Z145-300

The case for upholding existing planning for PD-462

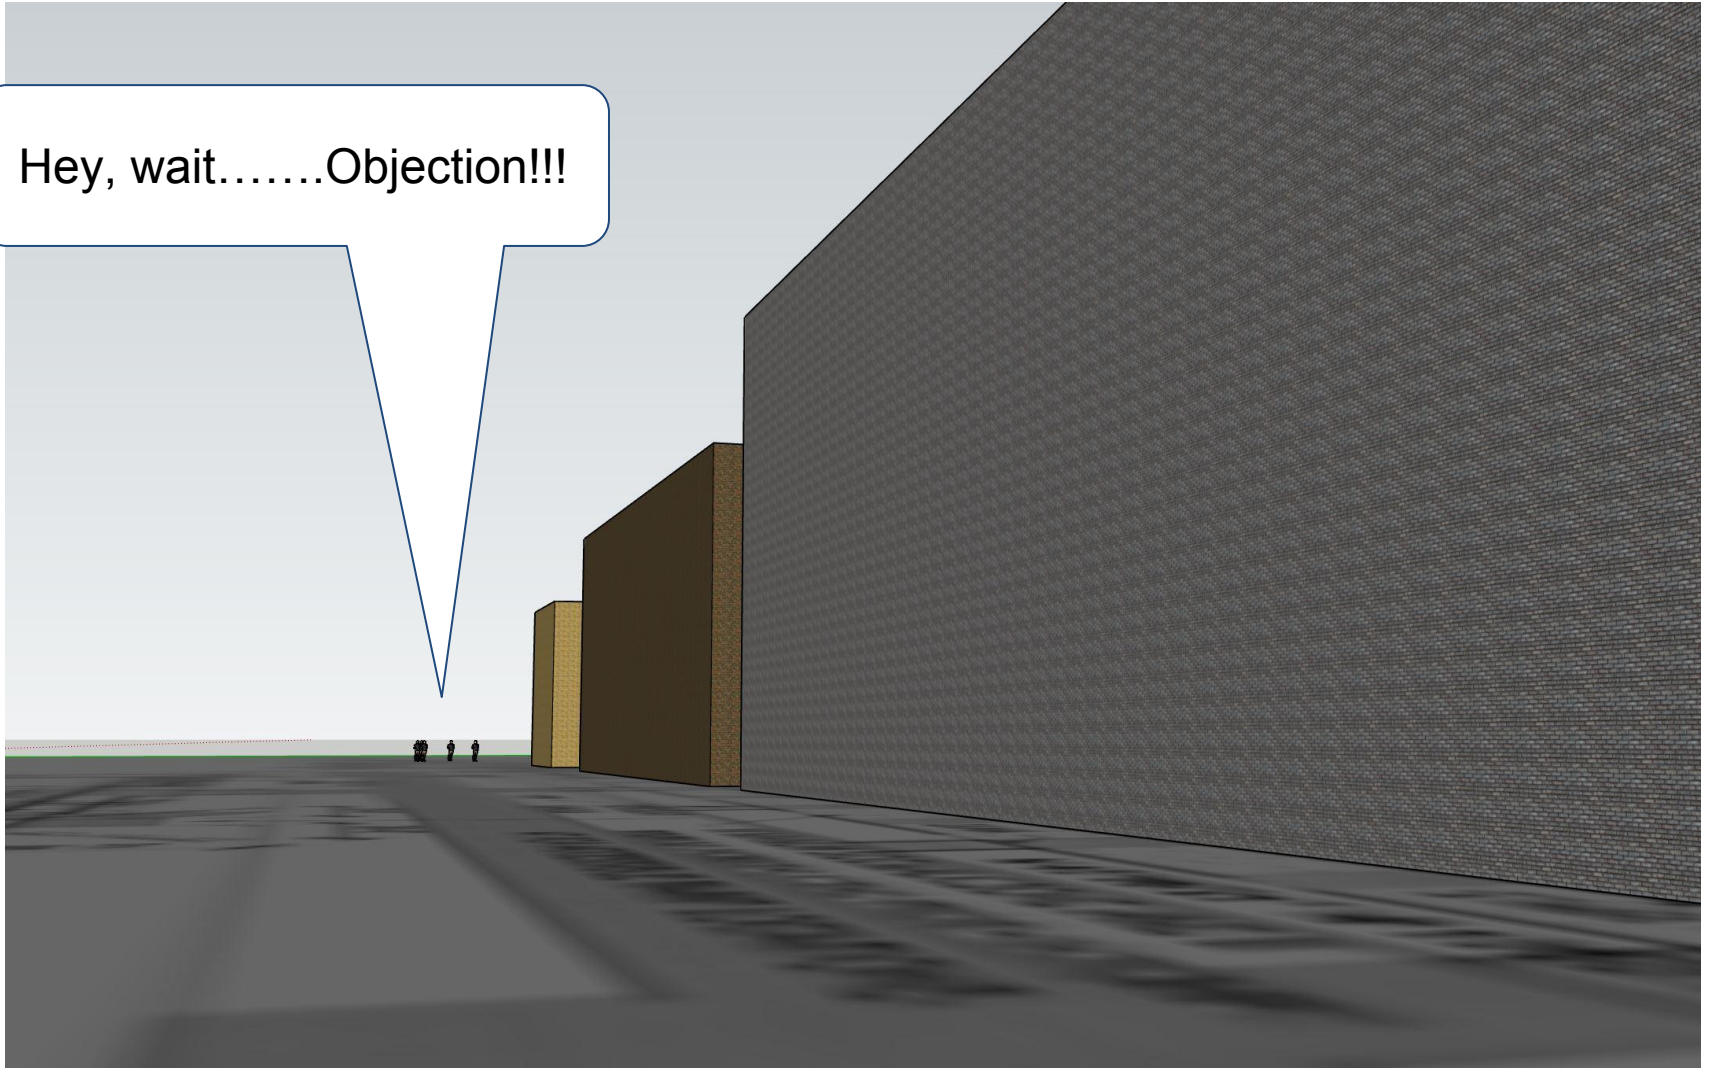
Put tree here.

When architects want to make big scary things look smaller, they use a little artist's voodoo trick called "forced perspective." By placing an imaginary camera close to a "human scale" everything close looks big, and everything in the distance looks small.

*drawn using the applicant's latest site plan...no details, just raw footprint and height.

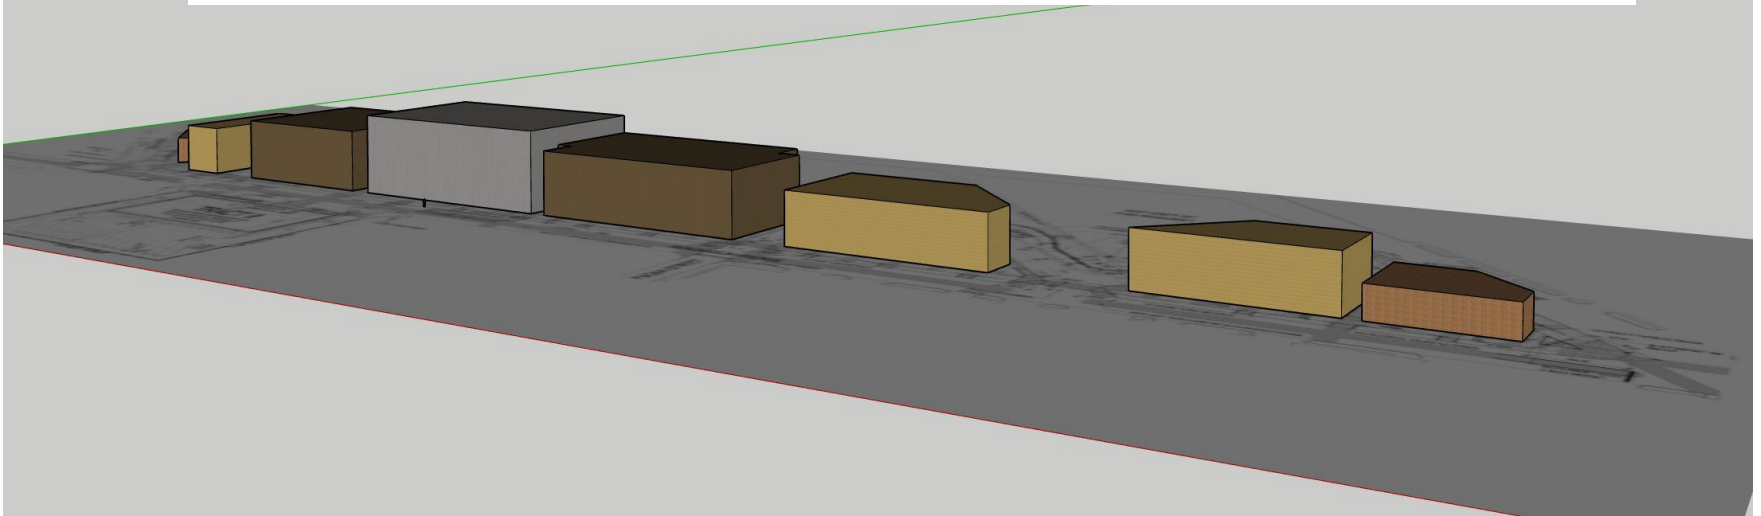
Because we've moved the camera far enough away where distance relationships are no longer distorted, we can get a true picture of the applicant's scale. But take a note, here. Remember how he's said he only has one 48-foot building, and most of them are way smaller?

Actually not so much. You can see the 48-footer in the grey. Our little human is that speck in front of it. The two brown ones are 45-feet. All of them are located on the LOW DENSITY RESIDENTIAL TRACT.

It's an upzoning. And don't forget there's a two lane road behind those buildings, that carries 6650 cars. At least. All on a string of single family depth lots.

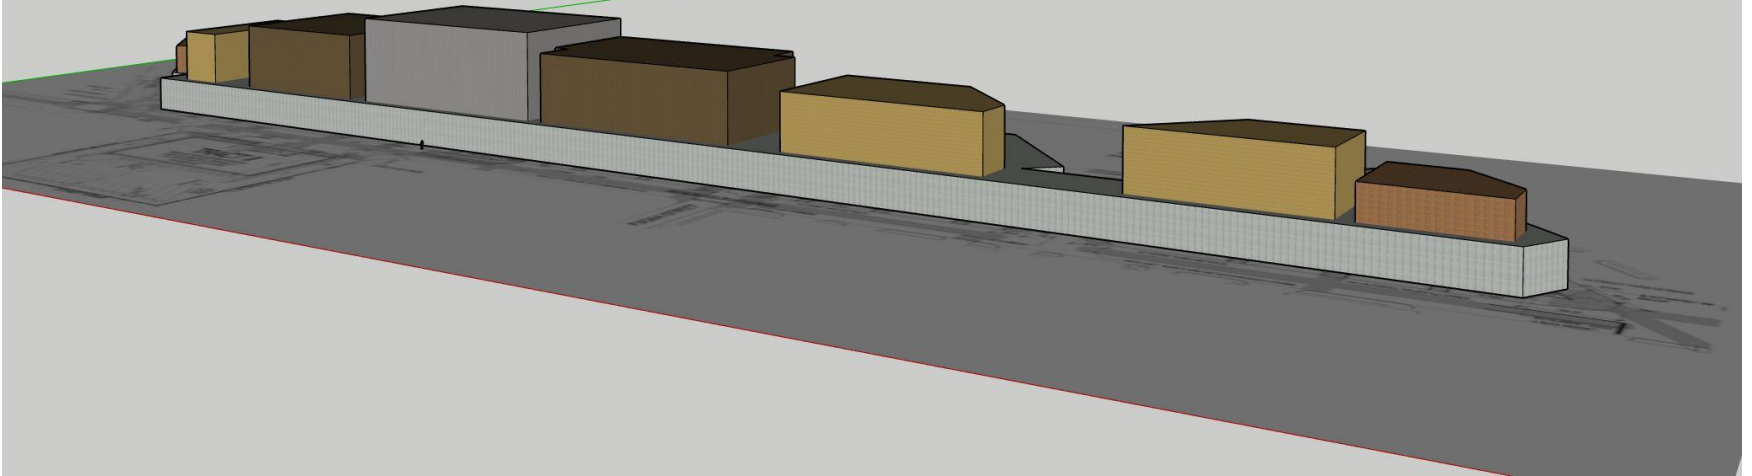
But if you really want the full impact, let's dig up that parking garage, because burying it might help the visual, but it doesn't take away a single car trip. Remember the low-density custom multifamily that exists here by right? That nice picture? This is an upzoning, a huge one.

The worst aspect? All of this parking is, in essence, an offsite parking garage for Subdistrict 3 and 5 uses, enabling intensity they were never intended to have. That's why the traffic count is low, and this is important. THE TRAFFIC STUDY LEAVES IT OUT ENTIRELY. Never mind parking agreements for C/Os, because the applicant doesn't need them. That is a distraction. This parking can be used after hours and weekends without restriction for other sites, and none of that traffic was counted. And in fact, the entire strip across the street could be rooftop decked, with this parking used to accommodate it, and you can't control it.

That is the reason this mix, this location, and this glut of parking is before you.

NEIGHBORHOOD SUPPORT MAP

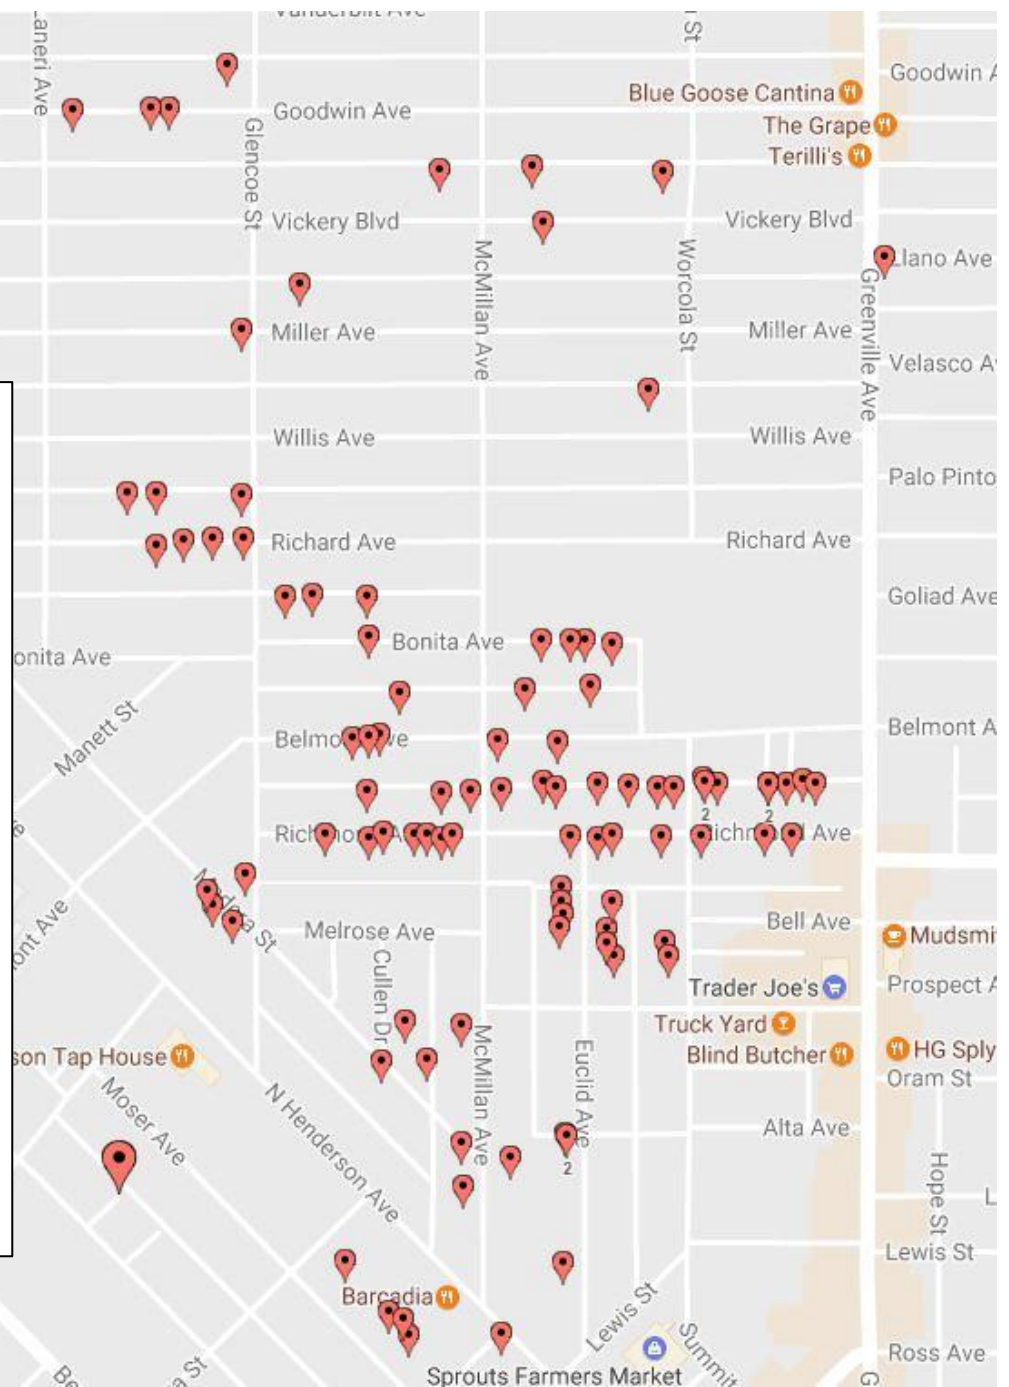
But if we color the applicant's land in the dark purple, and color developers, commercial interests, and LLC in dark green, then a different picture emerges.

The ratio of for/against among actual residents is not the overwhelming ratio the applicant claims.

In fact, if you expand the map to nearby areas which are affected already by Henderson Avenue traffic problems, the ratio actually reverses!

Out of 214 owners in the notification area, only 53 Single Family residents supported it.

But zoom out just a little, and 106 residents oppose it. We literally had to stop taking names so I could print it.

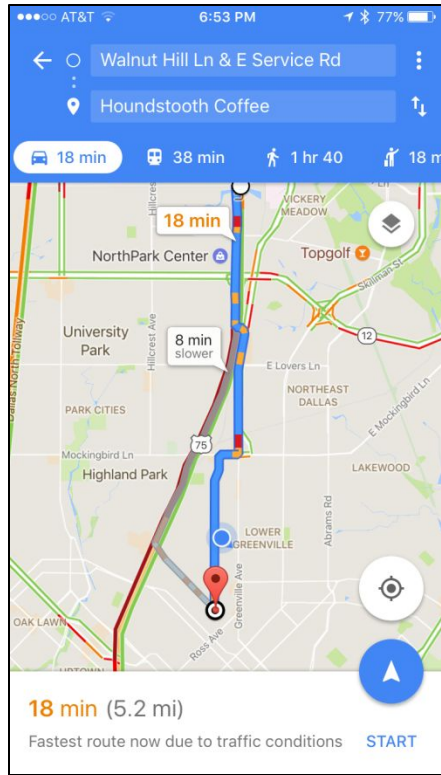
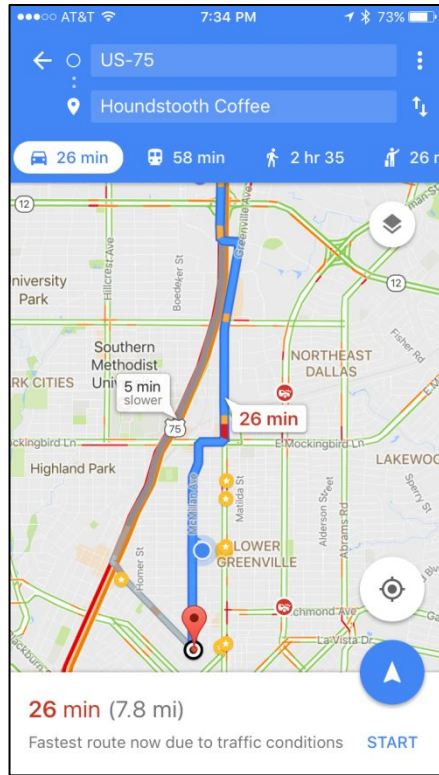
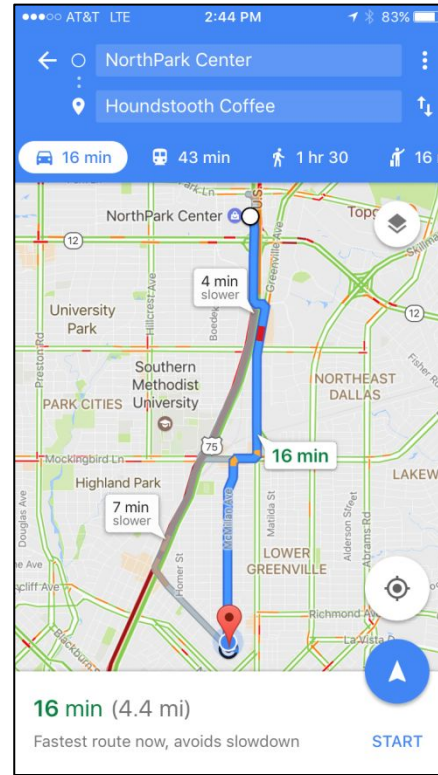
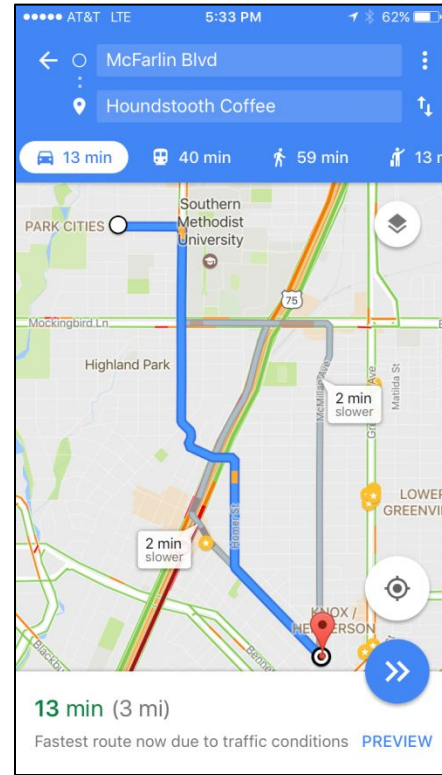
Henderson and Glencoe. BE SAFE!

The site's design will exacerbate this flooding. But worse, homes behind the site are not significantly raised. The alleyway cannot be crowned significantly.

Especially in the "divot" portion of the site's eastern wall, the chance of flooding for residential properties, due to backed up water, is severe. There is no place for it to go, and no place to divert it.

Google Maps is already routing weekend traffic through our neighborhood's streets... this without the additional 6650 cars (a 56% increase) clogging Henderson Avenue from this proposed development.
